**Meeting:** 5/21/2026  
**Applicant:** Marlow Payant  
**Owner:** Marlow Payant

**Location:** 1321 Armstrong Ave. **Parcel ID** 81 L F 006  
**District:** Old North Knoxville H  
**Zoning:** RN-2 (Single-Family Residential Neighborhood)  
**Description:** Queen Anne with Neoclassical Influence, c.1910

Staff recommends approval of Certificate 5-F-26-HZ, subject to the following conditions:

**5-F-26-HZ**  
**APPLICATION FOR CERTIFICATE OF APPROPRIATENESS**

### 3. Chimney:

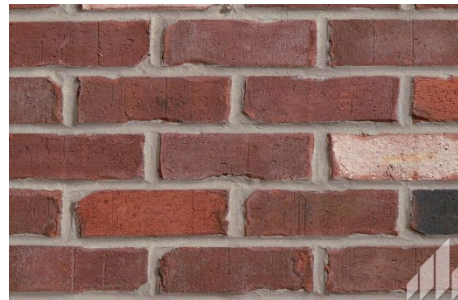
- 1) the small shingles in the gable fields be retained;
  - 2) the design of the replacement chimney to replicate the existing, with final drawings to be approved by staff and included on plans submitted for permitting; and
  - 3) the replacement window trim to match the existing, with final drawings to be approved by staff.
-

3. The original brick chimney was stuccoed prior to 1992, and the applicant states it is “falling to pieces all throughout.” The guidelines encourage removing and replicating chimneys that are too deteriorated to repair using remaining physical evidence, so removal can be appropriate. However, the new proposed chimney will not match the exact design of the original chimney, which narrows at the second story where the smoke chamber meets the flue, characteristic of operable chimneys from the period. The design of the replacement chimney should be revised to include this narrow section, with final drawings to be approved by staff.
